# NX 3.0.22.00 / NX 4.0.22.00

## Service Bulletin

### NX 22.00 SU1 available

Figure 1

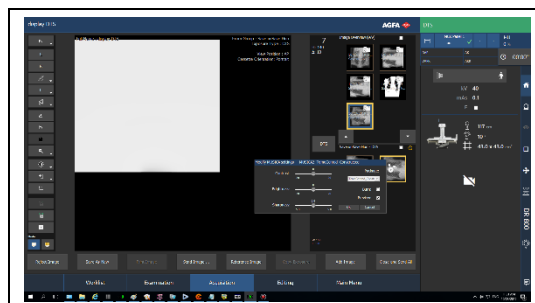
### 1.6.1 A white image is displayed when modifying MUSICA parameters of a dynamic sequence [PRB2000413]

**Symptom** Sporadically, when modifying MUSICA parameters of a dynamic sequence, the actual image is not displayed anymore. Instead, either the previous image or a white image or an error is shown (if no previous image is available).

After closing the “Modify MUSICA Settings” pop-up window, the parameters are applied on the correct image, and the correct image is shown.

The error appeared on NX 22.00 at inhouse tests, and may happen on DR 600 or DR 800. Dynamic sequences can be recorded on these two systems only.

**Solution** Update to NX 22.00 SU1. There the issue is solved.

Figure 2

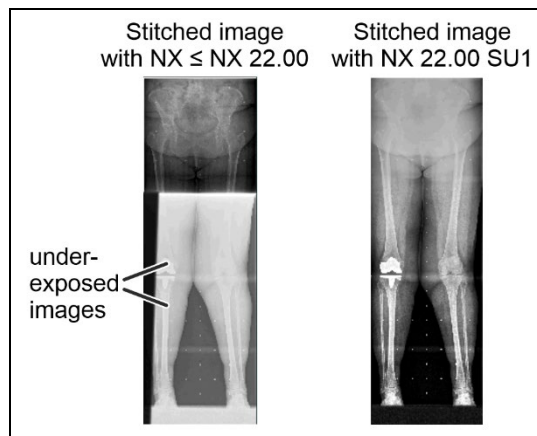
- In NX 22.00 and earlier versions, when the exposure index between the partial Full Leg Full Spine (FLFS) images exceeded a certain limit, the gain factors were not computed correctly. This resulted in an inhomogeneous stitched image.
